To: Richmond City Council **Date:** November 23, 2006
From: Councillor Harold Steves **File:** 12-8060-20-8115
Chair, Planning Committee
Re: **APPLICATION BY H.A. BERG INVESTMENTS LTD. FOR REZONING
AT 11991 NO. 1 ROAD AND 3931 CHATHAM STREET FROM SERVICE
STATION DISTRICT (G2) TO STEVESTON COMMERCIAL (THREE-
STOREY) DISTRICT (C5)**

Staff Report

Attachment 2: Conceptual Development Plans

ROOF DECK LEVEL

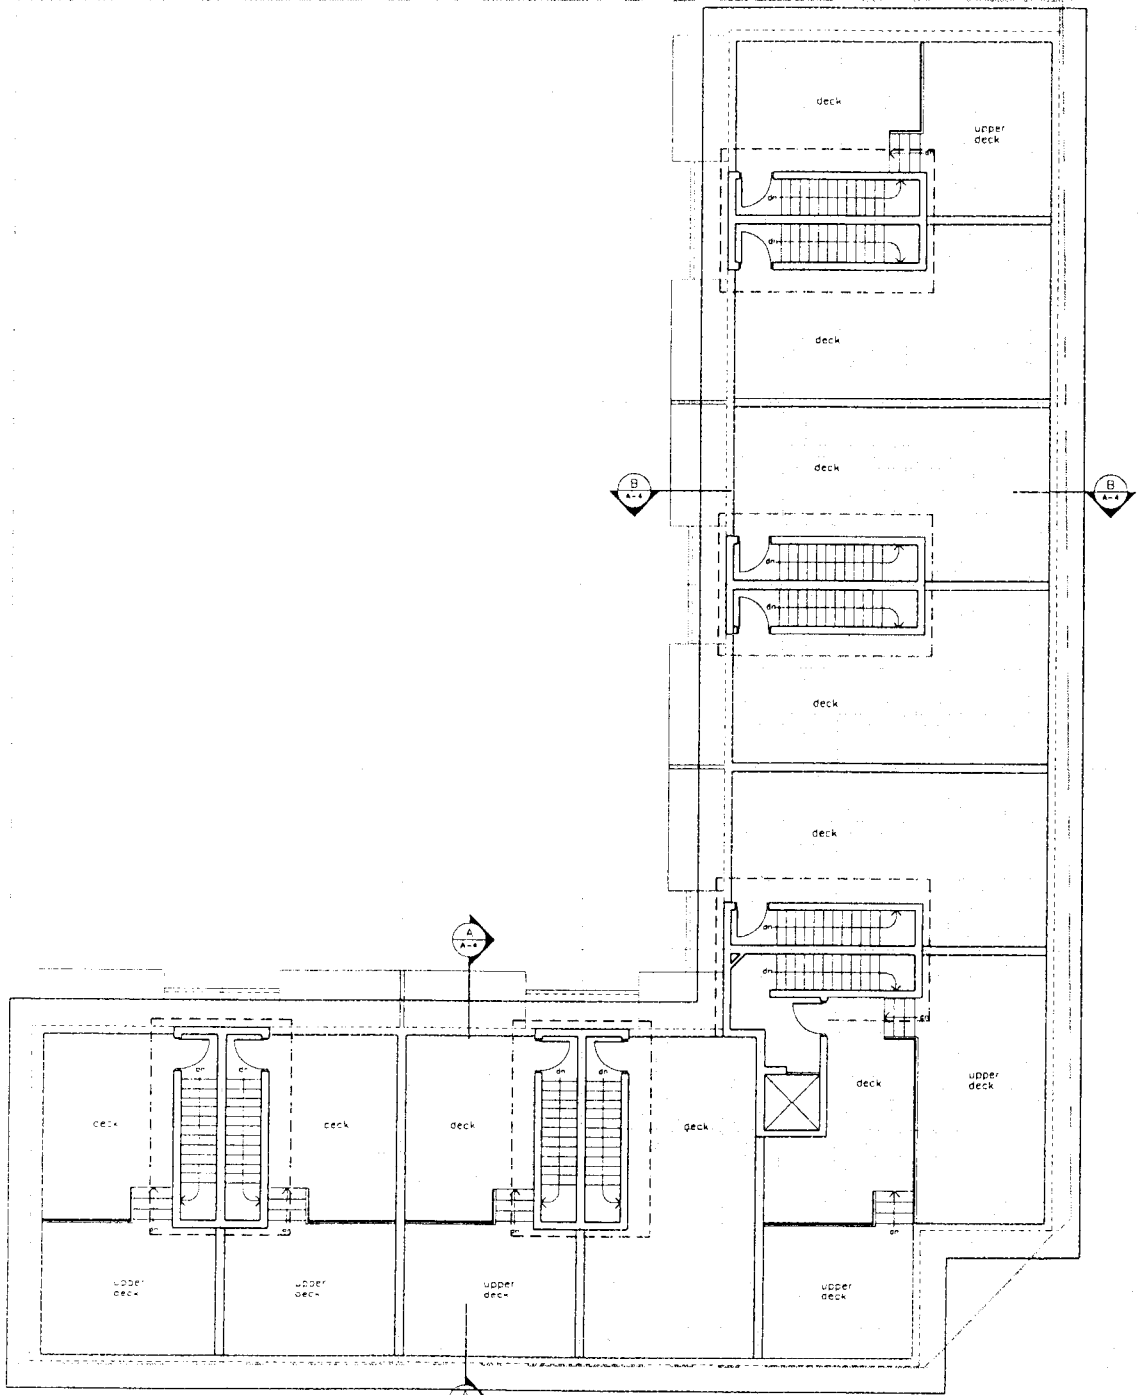
- (1) That Bylaw No. 8115, for the rezoning of 11991 No. 1 Road and 3931 Chatham Street from "Service Station District (G2)" to "Steveston Commercial (Three-Storey) District (C5)", be introduced and given first reading.*
- (2) That Rezoning application 05-296591 be referred back to staff in order for staff and the applicant to:
 - (i) revise the proposed exterior, including finishing materials, and the awning design to reflect more heritage character;*
 - (ii) incorporate a community garden on the roof deck; and**
- (3) That the applicant present modified drawings at the Public Hearing*

- the design at the street corner is subdued and presents an opportunity for development of something more visually interesting; design improvement at the Development Permit stage is expected
- the revised design is honest and more in tune with historic Steveston
- the redesign of the roof deck is an improvement
- the step down at the north end is not supported, given the distance from the existing single family home to the north across the lane.
- the frontage of the service rooms needs more work. The rhythm of the frontage treatment needs to be continued.
- the openings to the residential entrances at the two ends of the building seems weak and can be strengthened by incorporation of an iron gate or some better treatment
- the design of the parking lot and the residential entrances along the back of the first floor can be further improved at the Development Permit stage

WEST ELEVATION

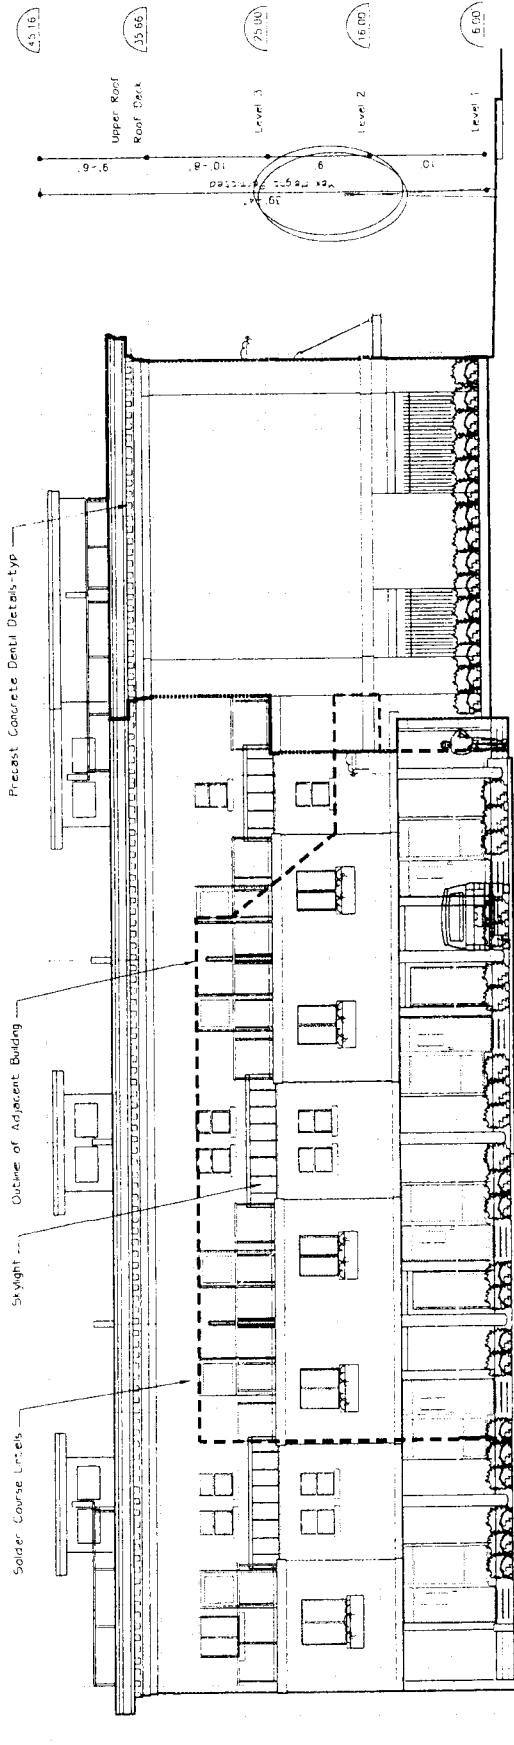
- The current design has incorporated windows on the west elevation. The building is built close to the property line, there might be limiting distance issues with respect to the amount of proposed openings.

EAST (NO. 1 ROAD) ELEVATION

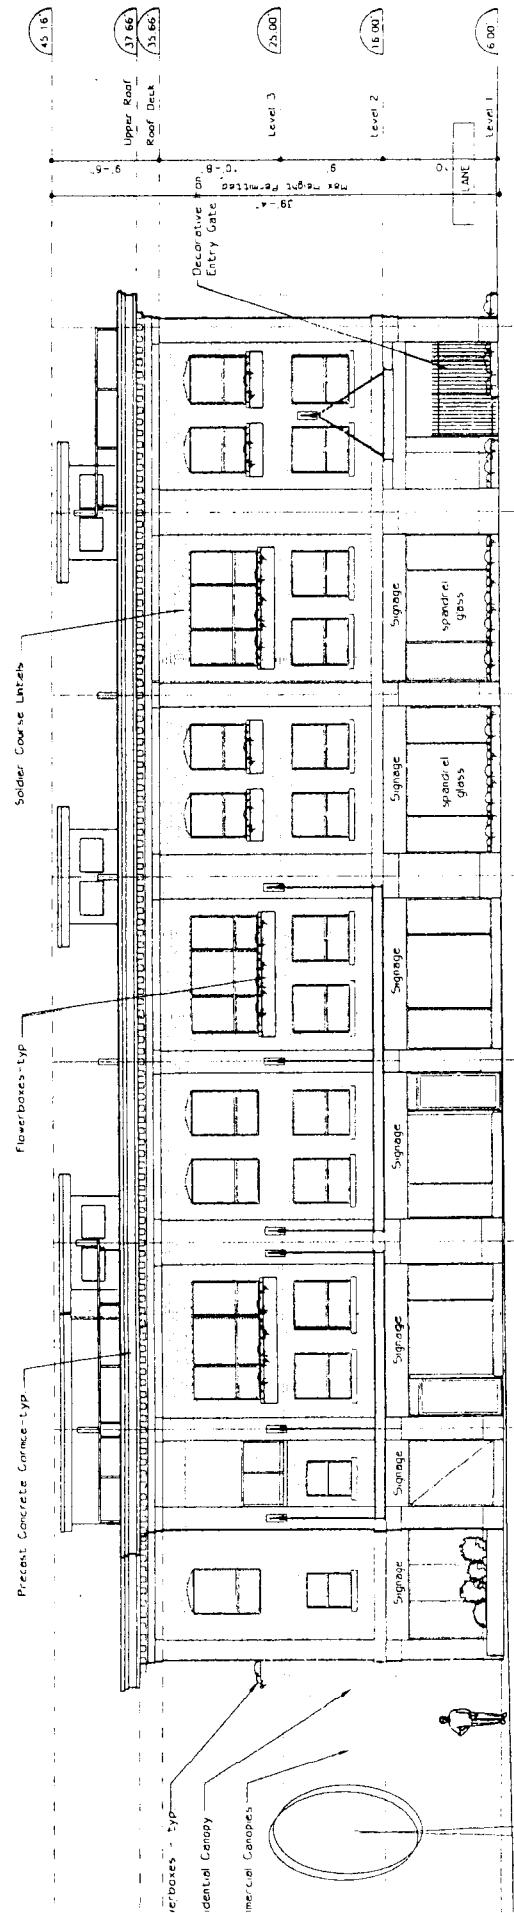
- The Heritage Commission recommended design development to the No. 1 Road façade at grade to provide continuous frontage including the mechanical and storage areas as part of the Development Application process.

- The Heritage Commission recommended design development to the No. 1 Road façade at grade to provide continuous frontage including the mechanical and storage areas as part of the Development Application process.
